## 6.2 Containment Systems

The information in this section of the reference ABWR DCD, including all subsections, tables, and figures, as modified by the STP Nuclear Operating Company Application to Amend the Design Certification rule for the U.S. Advanced Boiling Water Reactor (ABWR), "ABWR STP Aircraft Impact Assessment (AIA) Amendment Revision 3," dated September 23, 2010 is incorporated by reference with the following departures and supplements.

STD DEP 6.2-2 (Tables 6.2-1 and 6.2-2, Figures 6.2-2, 6.2-3, 6.2-4, 6.2-5, 6.2-6a and b, 6.2-7a and b, 6.2-8a, 6.2-8b, 6.2-8c, 6.2-9, 6.2-10, 6.2-11, 6.2-12a and 6.2-12b, 6.2-13a and 6.2-13b, 6.2-14, 6.2-15, 6.2-22, 6.2-23a, 6.2-23b, 6.2-24, 6.2-25a, and 6.2-25b.)

Figure 6.2-3 Feedwater Line Break Flow—Feedwater System Side of Break

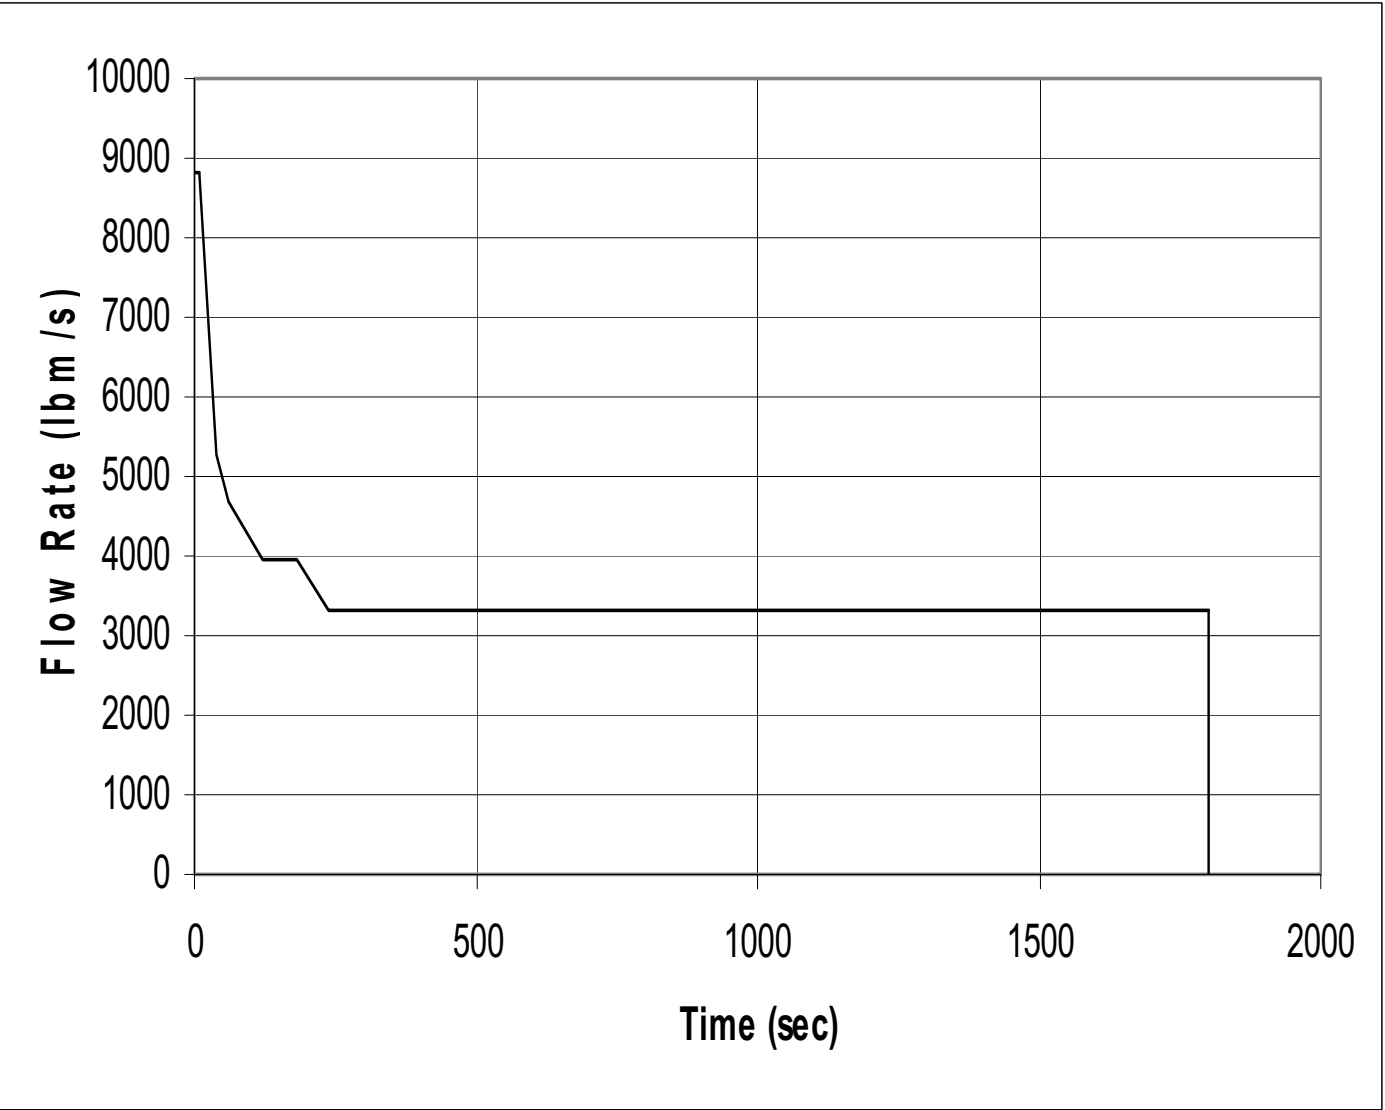
~~The maximum possible feedwater flow rate was calculated to be 164% of nuclear boiler rated (NBR), based on the response of the feedwater pumps to an instantaneous loss of discharge pressure. Since the Feedwater Control System will respond to decreasing RPV water level by demanding increased feedwater flow, and there is no FWLB sensor in the design, this maximum feedwater flow was conservatively assumed to continue for 120 seconds (Figure 6.2-3). This is very conservative because:~~

In order to provide further assurance of conservatism, FWLB mitigation is added to the ABWR design. The system is described in Section 7.3.1.1.2. The specific enthalpy time history, assuming the break flow of Figure 6.2-3, is shown in Figure 6.2-4. Initial reactor power is assumed to be 102% NBR.

Figure 6.2-6a Drywell Pressure Response for Feedwater Line Break

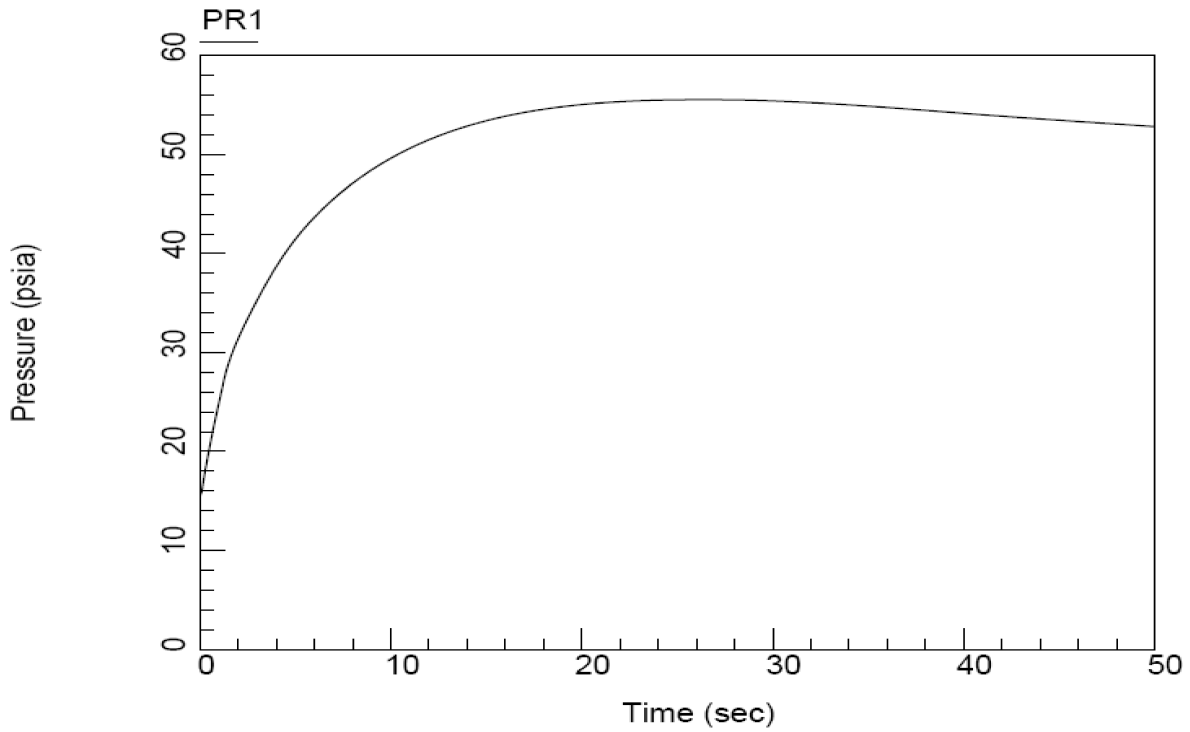
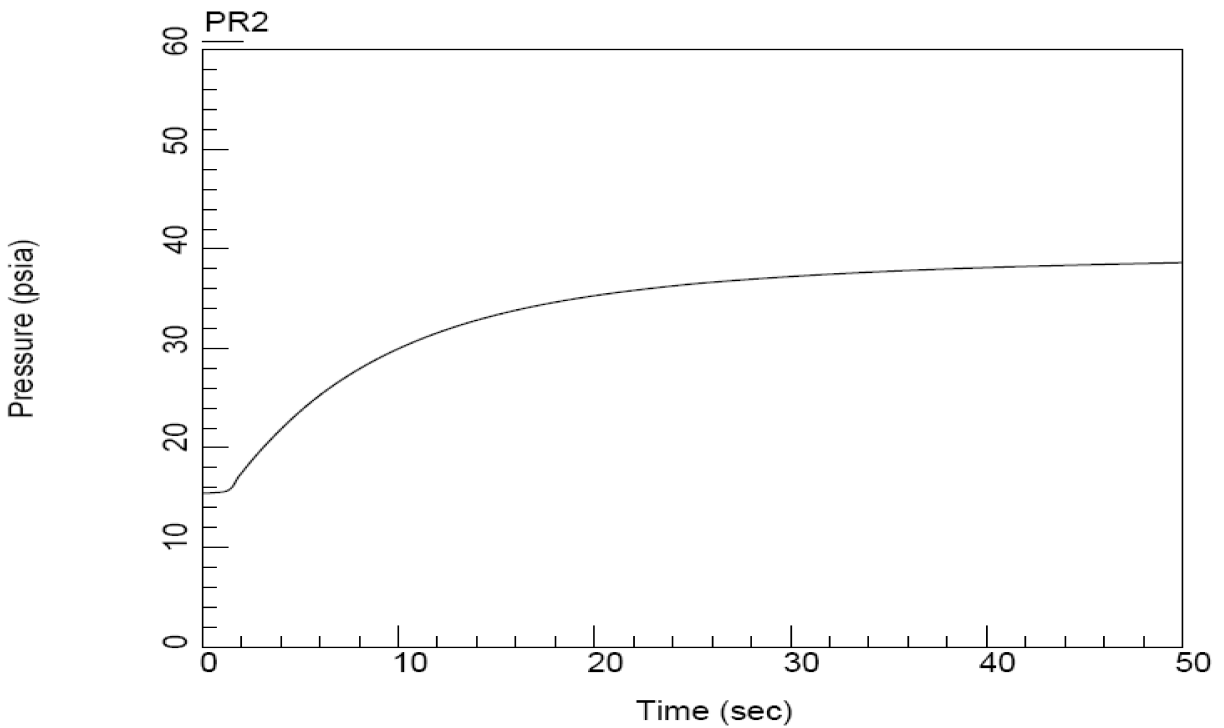
~~The calculated containment pressure and temperature responses for a feedwater line break are shown in Figures 6.2-6 and 6.2-7, respectively. The peak pressure (268.7 kPaG) and temperature (140°C) occur in the drywell. The containment design pressure of 309.9 kPaG is 115% of the peak pressure.~~

*The short term pressure peak (268.7 kPaG) of Figure 6.2-6 is the peak pressure for the whole transient. Figure 6.2-8 shows temperature time histories for the suppression pool, wetwell, and drywell temperatures. The peak pool temperature (99.6°C) is reached at 6600 seconds (1.833 hours). This is less than the suppression pool temperature value of 100°C which is used in the net positive suction head available (NPSHA) calculations for RHR and HPCF.*

Figure 6.2-9 ABWR Main Steamlines with a Break

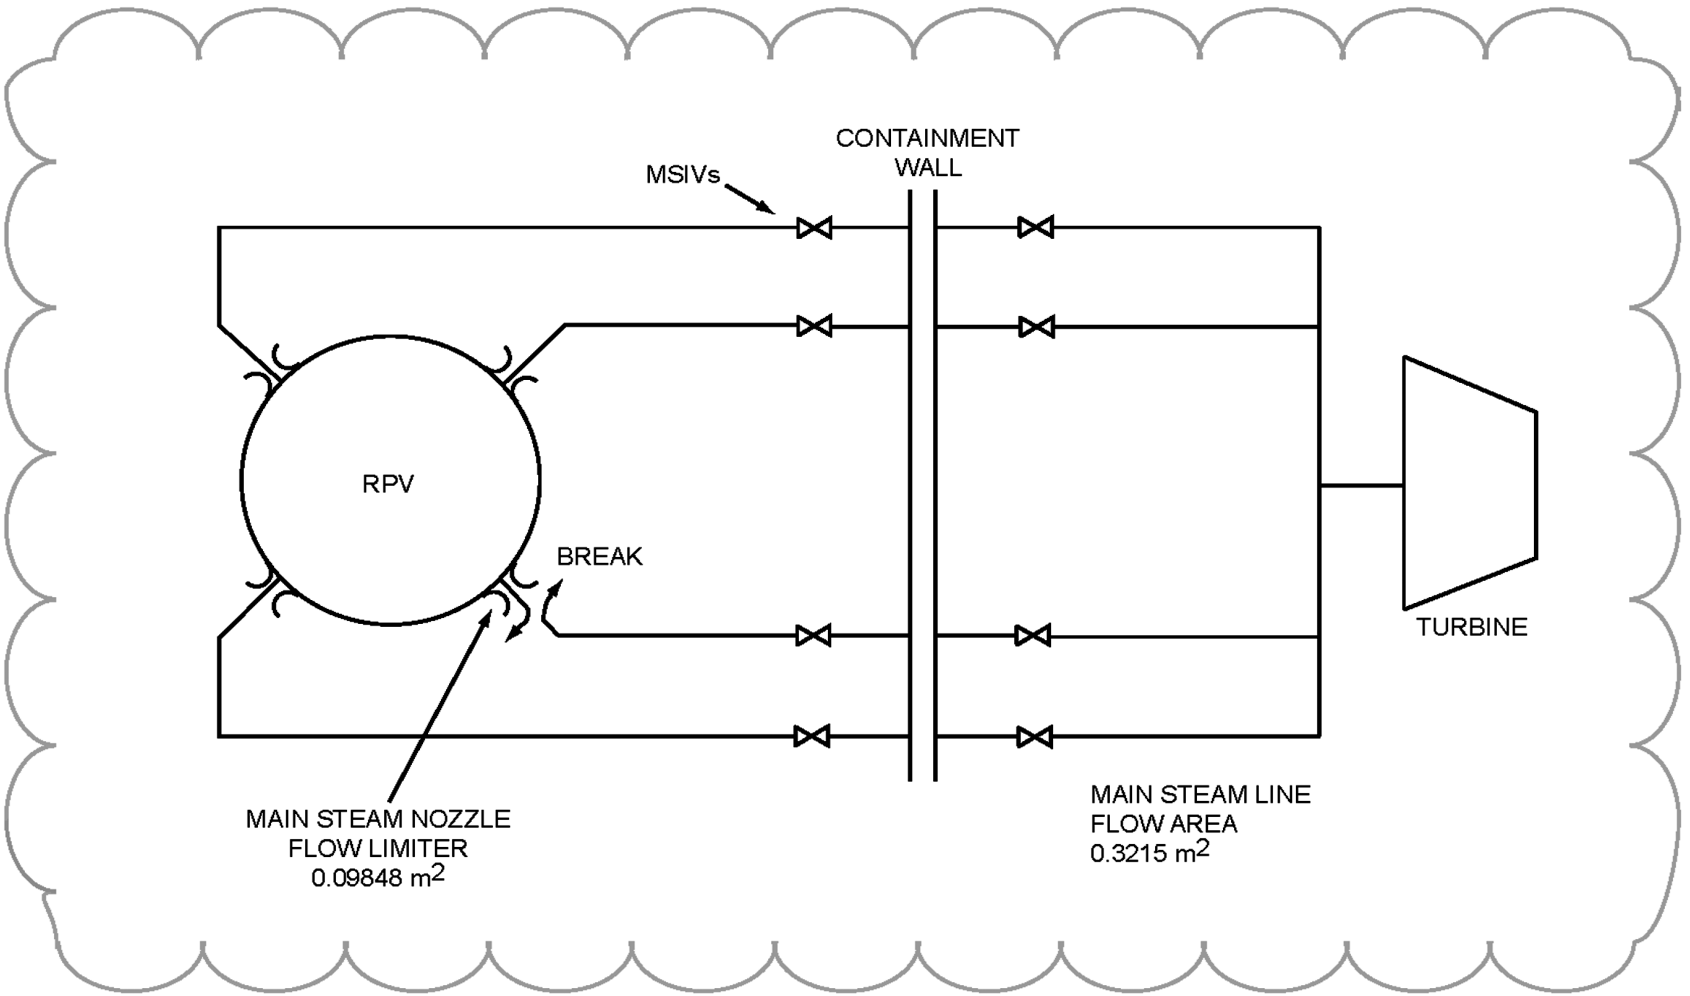
*A schematic of the ABWR main steamlines, with a postulated break in one of the main steamlines, is shown in Figure 6.2-9. The main steamline (MSL) break is a double-ended break with one end fed by the RPV directly through the broken line, and the other fed by the RPV through the unbroken main steamlines until the MSIVs are closed. Once the MSIVs are closed, the break flow is only from the RPV through the broken line.*

Each MSL contains a flow limiter built into the MSL nozzle on the RPV with a throat area of 0.09848 m<sup>2</sup>, as shown in Figure 6.2-9. This flow limiter provides the effective break area for the vessel side.

- (1) Each MSL contains a flow limiter built into the MSL nozzle on the RPV with a throat area of 0.0983m<sup>2</sup>, as shown in Figure 6.2-9.*
- (2) The break is located in one MSL at the inboard MSIV.*
- (3) During the inventory depletion period, the flow multiplier of 0.75 is applied (Reference 6.2-1).*
- (4) The flow resistance of open MSIVs is considered. A conservative value of 2.062 for pressure loss coefficient for two open MSIVs was taken. The nominal value is approximately 3.0. When the open MSIV resistance is considered, the flow chokes at the MSIV on the piping side as soon as the inventory depletion period ends. The effective flow area on the piping side reduces to 70% of a frictionless piping area. The value of 70% applies to flow of steam and twophase mixture with greater than 15% quality.*

Figure 6.2-12a Drywell Pressure Time History for MSLB

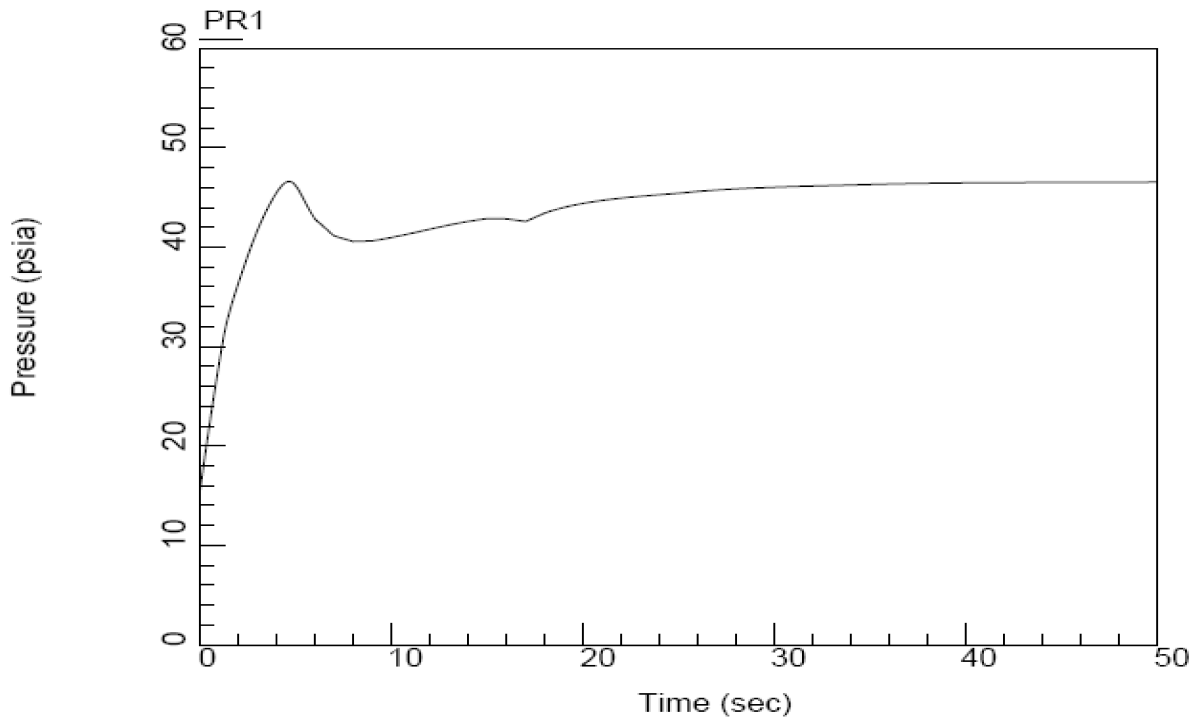
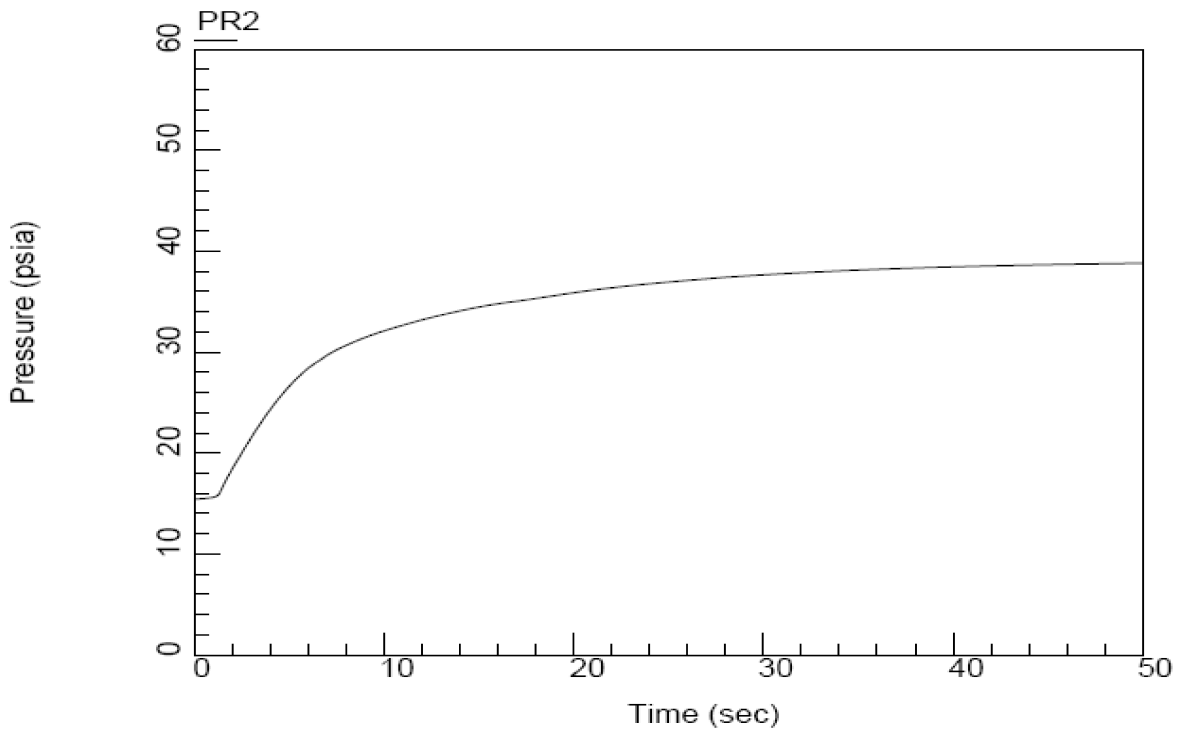
*Figures 6.2-12 through 6.2-15 and 6.2-13 show the pressure and temperature responses of the drywell and wetwell during the blowdown phase of the steamline break accident.*

Figure 6.2-13a Drywell Temperature Time History for MSLB

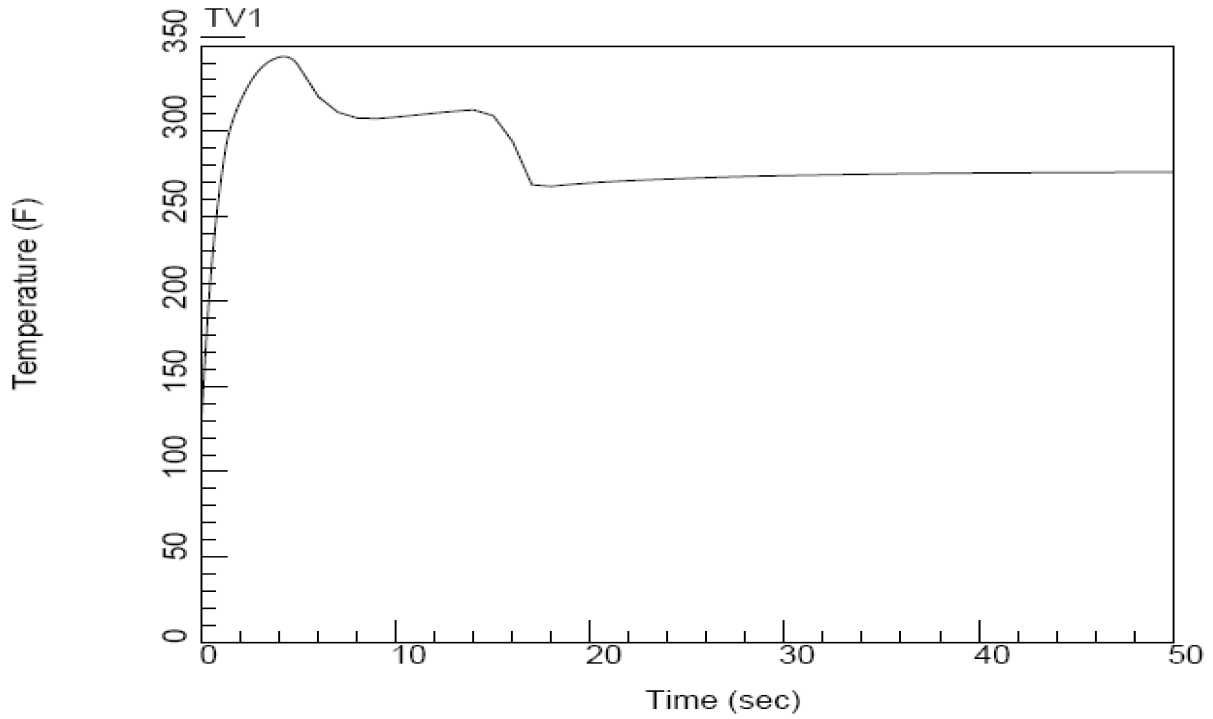
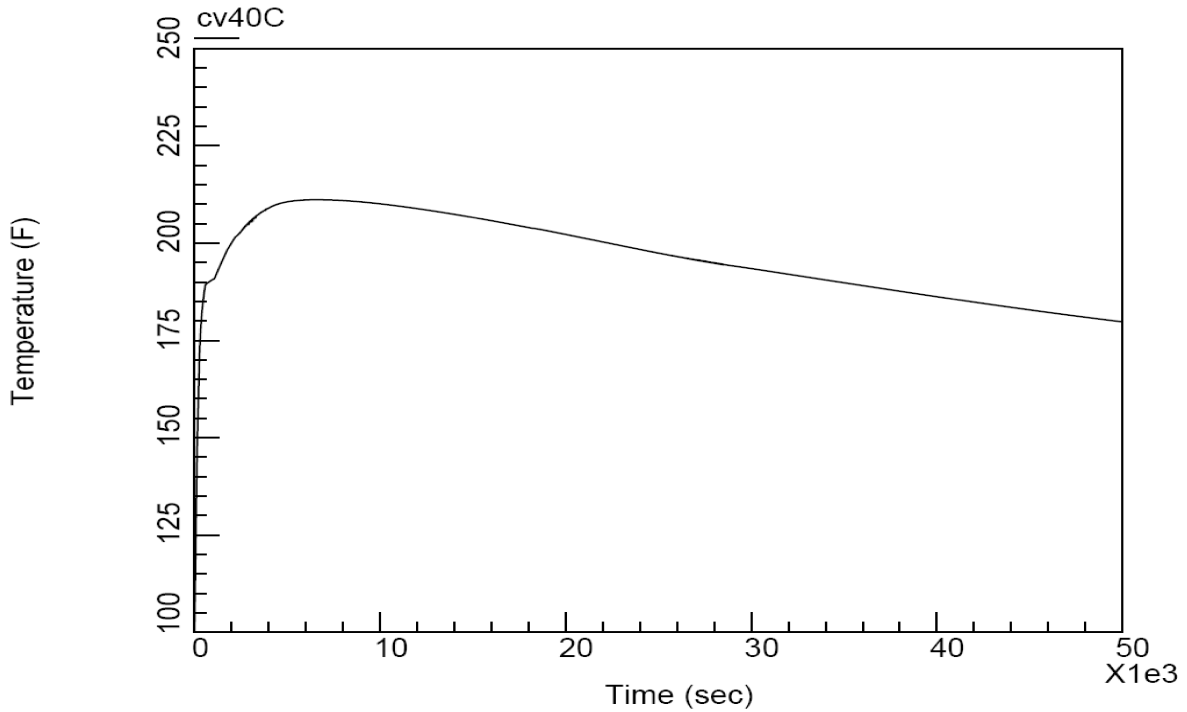
*The long term containment pressure and temperature responses following the MSLB accident remain below those for the feedwater line break, which is the most limiting event. The long-term containment pressure response following the MSLB accident remains below that for the feedwater line break. The long-term temperature response remains below that for the peak achieved in the short term for the steam line break shown in Figure 6.2-13.*
